# Access Compliance Report Public Rights-of-Way (Curb Ramps)

Intersection ID: 32311	Main Street: LAUREL_WALK_CT	Cross Street: NEW_PROVIDENCE_LN	Location: NW
ADA ID: B0A2932AA10C	Ramp Type: Perp	Initial Pass/Fail: Fail	Overall Compliance: No Severity Score: 13.75

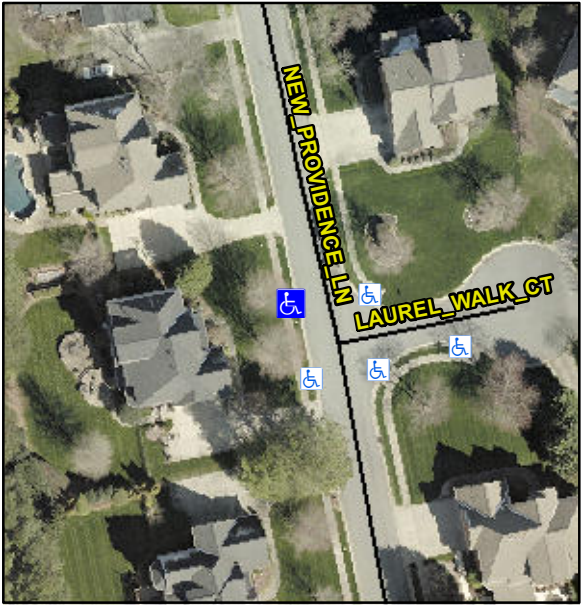
Possible Solutions:  
**Remove & Replace Entire Ramp.**

PROW/ADA:  
**R304.2.2, R304.5.3**

Compliance	Description	Data	Compliance	Description	Data
N/A	Ramp Length (in)	46.0	No	Ramp Slope (%)	9.2
Yes	Ramp Width (in)	48.0	No	Ramp XSlope (%)	4.2
N/A	Flare Type LT	N/A	N/A	Flare Type RT	N/A
N/A	Flare Slope LT (%)	N/A	N/A	Flare Slope RT (%)	N/A
N/A	Flare Traversable LT?	N/A	N/A	Flare Traversable RT?	N/A
N/A	Landing Length (in)	N/A	N/A	DWS Provided?	N/A
N/A	Landing Width (in)	N/A	N/A	DWS Contrast?	N/A
N/A	Landing Slope (%)	N/A	N/A	DWS Length (in)	N/A
N/A	Landing X Slope (%)	N/A	N/A	DWS Full Width?	N/A
N/A	Landing Curb? (Y/N)	N/A	N/A	DWS Offset (in)	N/A
N/A	Shared Landing?	N/A			
N/A	Gutter Ponding?	N/A	N/A	Gutter Slope (%)	N/A
N/A	Gutter Lip Ht (in)	N/A	N/A	Gutter X Slope (%)	N/A
N/A	Painted X Walk1?	No	N/A	Painted X Walk2?	N/A
	X Walk 1 Direction	To E		X Walk 2 Direction	N/A
N/A	X Walk 1 Width (in)	N/A	N/A	X Walk 2 Width (in)	N/A
	X Walk 1 Slope (%)	3.9		X Walk 2 Slope (%)	N/A
	X Walk 1 X Slope (%)	1.7		X Walk 2 X Slope (%)	N/A
